Dear Trails Committee,

GTC Member Proposed Amendments to the Girdwood Trails Master Plan Jan 18 2022.  
Proposed changes may not be addressed in the order shown.

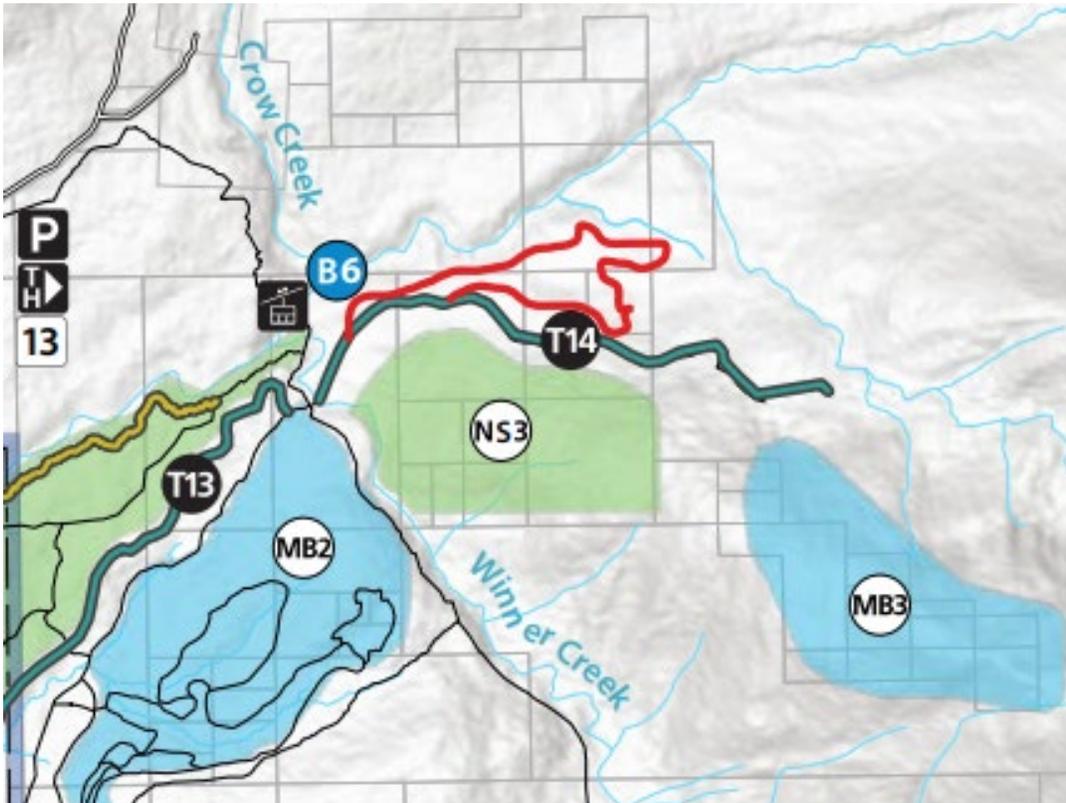
Amendment #2 (Tenny)  
Proposed change: Title - Virgin Creek Falls Trailhead. Keep bullet points 1,2,3  
Add bullet point 4: Upon completion of the study and review of the suggested alternatives by GTC there will be implementation of the preferred option.

Motion: GTC moves to approve Amendment #2 to Virgin Creek Falls Trailhead. Add bullet point 4: Upon completion of the study and review of the suggested alternatives by GTC there will be implementation of the preferred option.

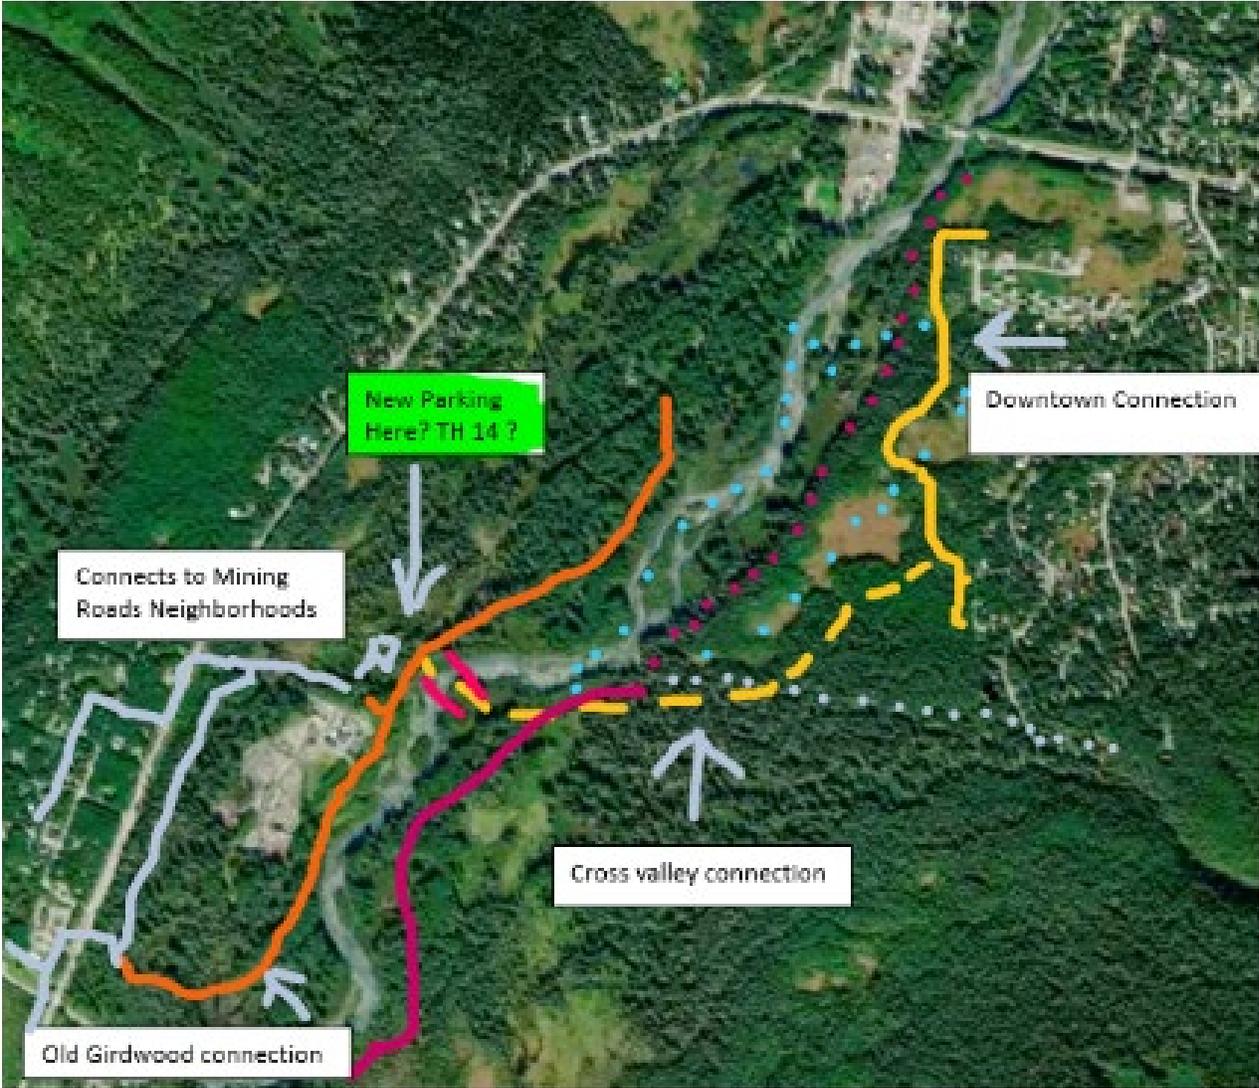
Proposed Motion: Add to the draft plan a new class 3 trail traversing parcel 6-036 and other nearby lands generally following the route that is indicated on the attached map.

GTC moves to add a new Class 3 trail traversing Parcel 6-036 and other nearby lands generally following the route that is indicated in the map (yellow, both dash and solid).

Proposed Motion: Add to the draft plan a new site to locate bridge 1. Remove from the draft plan the old location of bridge 1. Select the new location of bridge 1 to correspond with the southern termination of the trail described in motion 1. (eg Amendment 11)

Amendment 13:

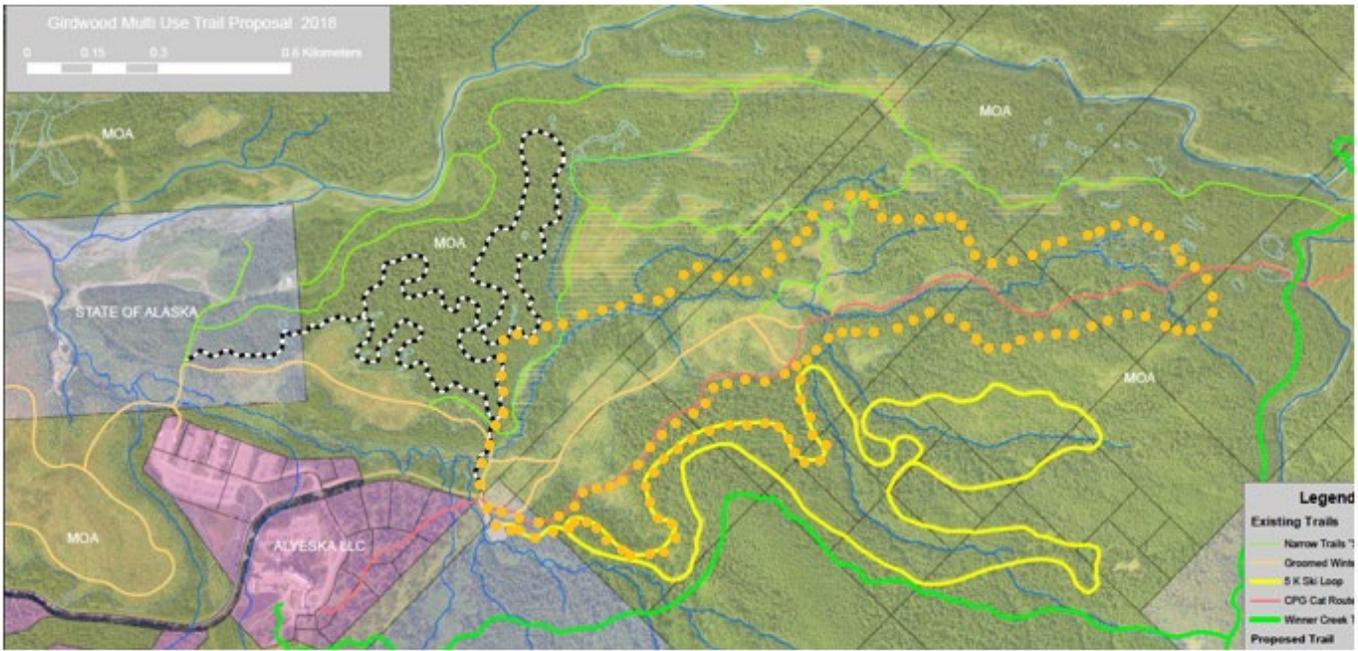
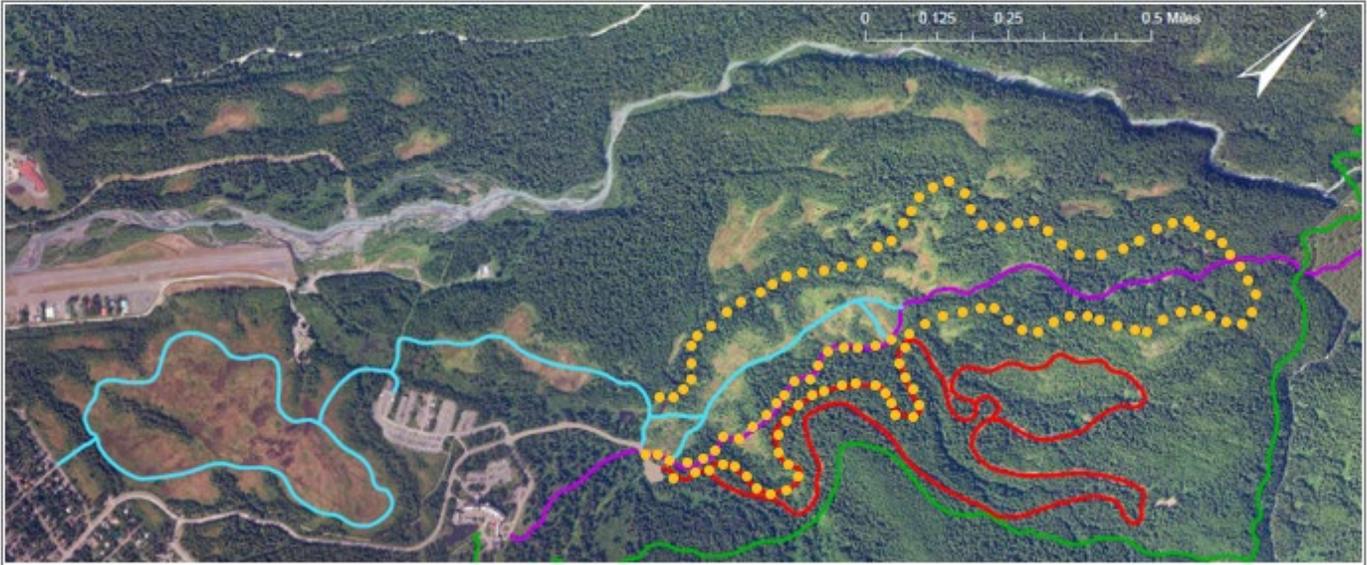
Proposed Motion: add back an Upper Valley Connector from the Forest Loop to the CPG CAT Track near the CAT Track Bridge. (see maps below)

Motion to add back an Upper Valley Connector from the Forest loop to the CPG Cat Track near the Cat Track Bridge.
